| Application made by: | CSJV | | | 25/09/2020 |
| LAA/LAP/Site Reference | Granby Terrace Bridge Utility Diversions | | | |
| Date of Tree Panel: | 25/09/2020 | | | |

The 4 trees on Harrington Street that require removal.

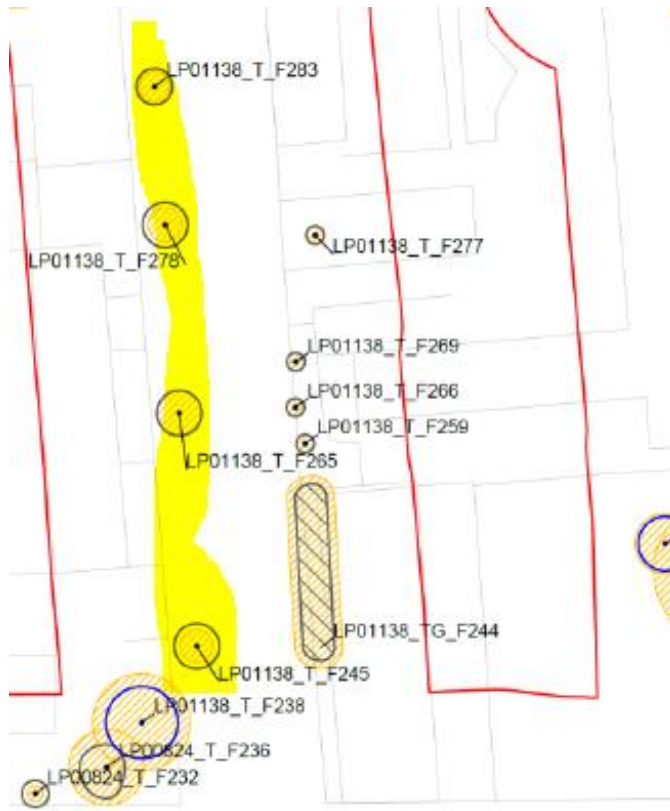
| Reason for clearance: | The purpose of the vegetation removal is to allow access for the excavator to carry out works associated with the Utility diversions around Granby Terrace Bridge. The tree's sit less than a metre from the edge of the utility trench, preventing the excavators from being able to work. The tree roots are at threat from extensive damage during the excavation works. | | | |
| Have all practicable means to negate need for works to tree been investigated? Please provide details | Yes, however the trees interface with the excavation associated with the Utility diversion works. | | | |

| | | Proposal Endorsed/Not Endorsed: | Endorsed with conditions |
| Conditions | <ul style="list-style-type: none"> -Site visit with HS2, CSJV, and LBC shows that the Norway Maples cannot feasibly be retained. -CSJV to update on timing of removal to allow for a community response to the proposal. -CSJV to pursue replanting in the area if possible. | | |
